From: Dan Spiller
Sent: Saturday, 15 January 2011 8:32 AM
To: 'jbs2000'; 'Bradley John'
Subject: Discussion Paper on Dam Full Supply Level Investigations Seqwater Gated Storages
Attachments: Discussion Paper on Dam Full Supply Level Investigations Seqwater Gated Storages.docx

Discussion Paper on Dam Full Supply Level Investigations Seqwater Gated Storages

DAM FULL SUPPLY LEVEL (FSL) INVESTIGATIONS

SEQWATER GATED STORAGES

JANUARY 2011 BRISBANE FLOOD **Assessment of Flood Levels at Brisbane City**

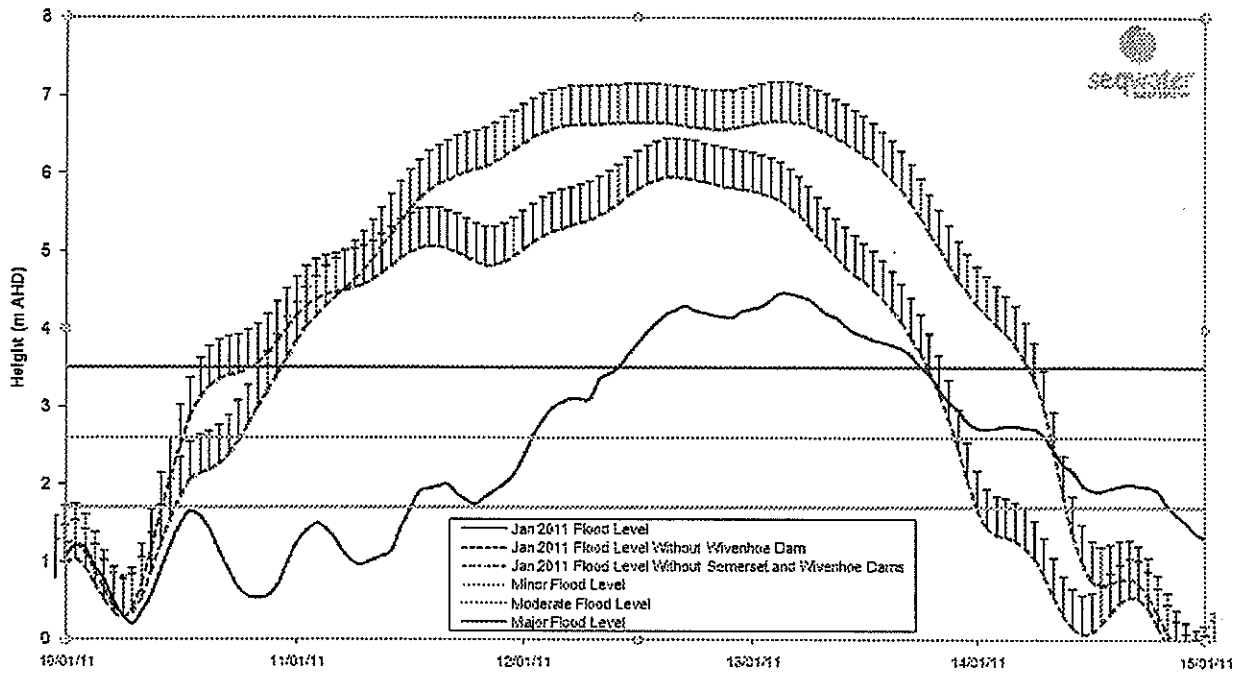
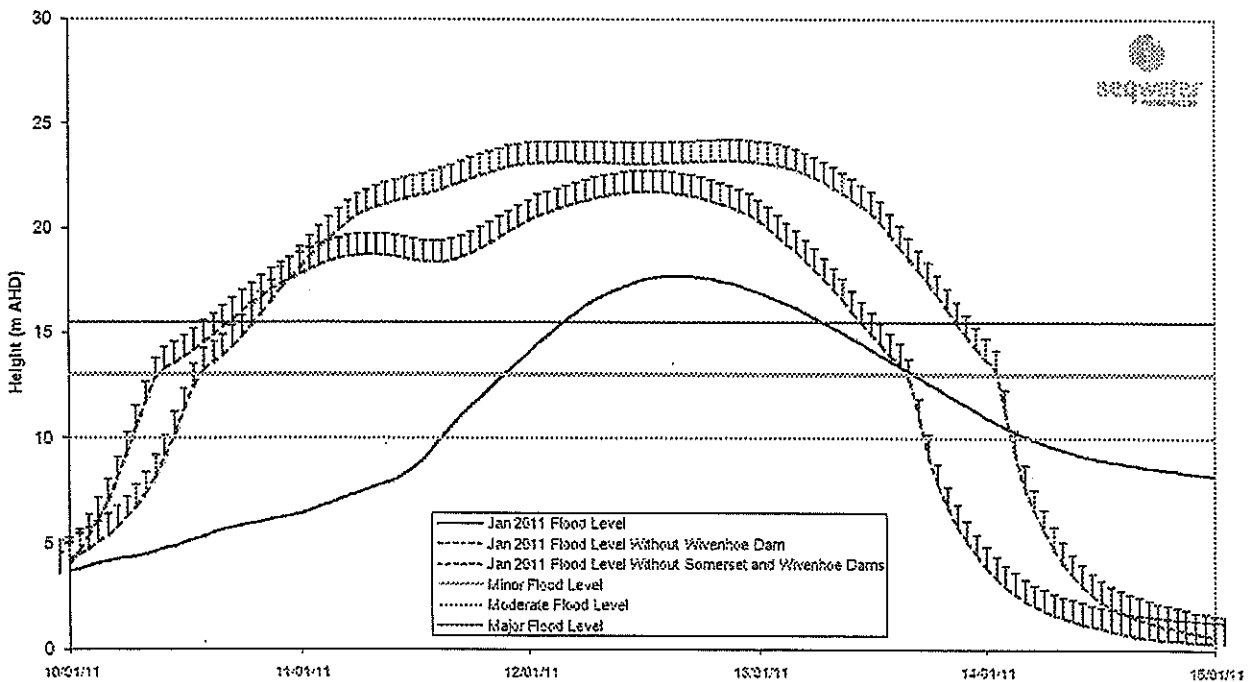
Blue line of graph – Breakdown the component of % of Wivenhoe Dam release and downstream inflows
